**CITY OF GOLETA
CALIFORNIA**

ADDENDUM NO. 2

FY 2016/2017 PAVEMENT REHABILITATION PROJECT– OVERLAY

PROJECT NO. 02-17

Shoulder Backing Detail:

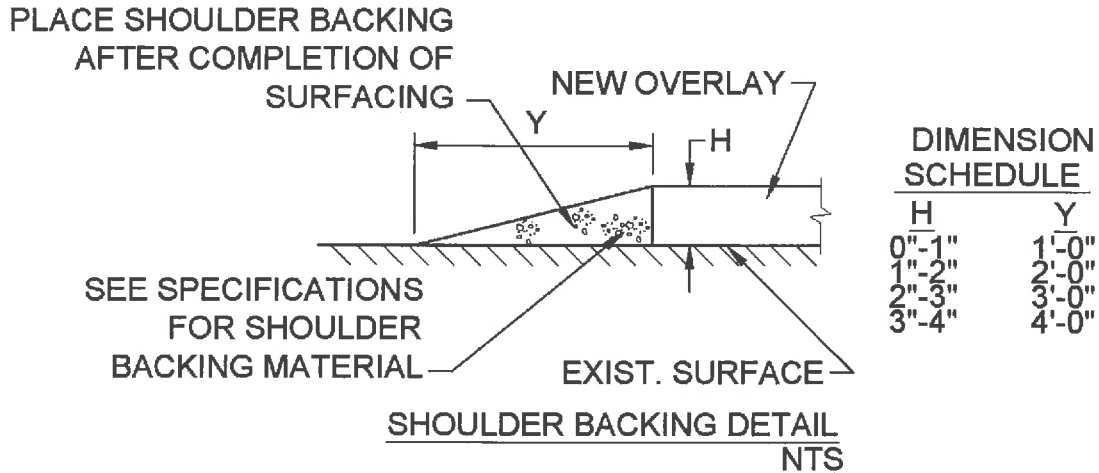
Add the following work limits and detail to the project plans: Shoulder Backing. Shoulder backing is located on the south side of Calle Real from Winchester Canyon Road westerly to the limits of work on Calle Real.
